NVM Express Technical Errata

Errata ID	020
Change Date	8/17/2011
Affected Spec Ver.	NVM Express 1.0b
Corrected Spec Ver.

This erratum adds a definition of LBA range.

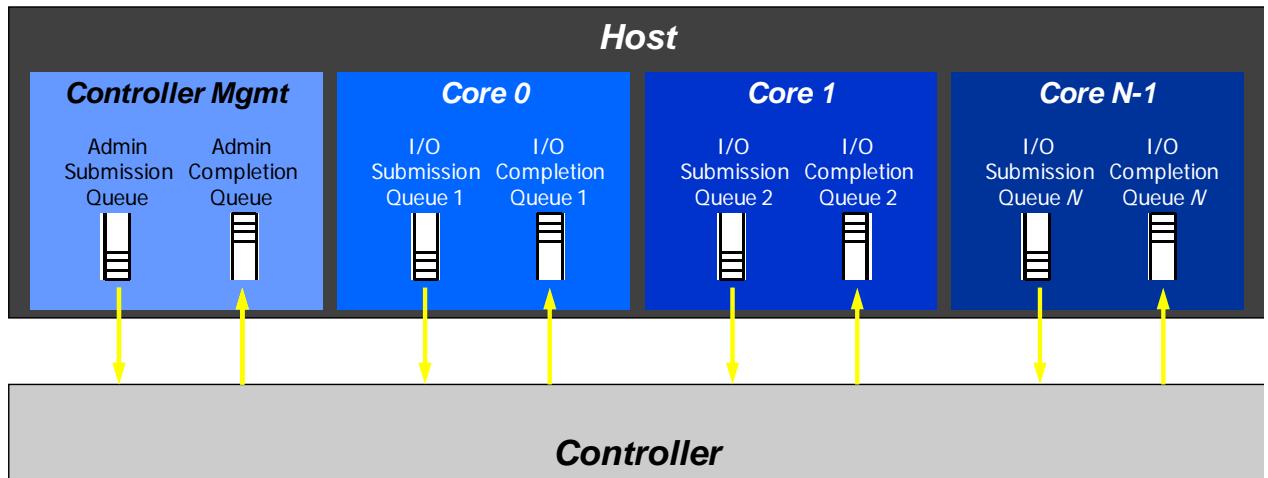
Update Figure 1 as shown (changing “Core N” to “Core N-1”):
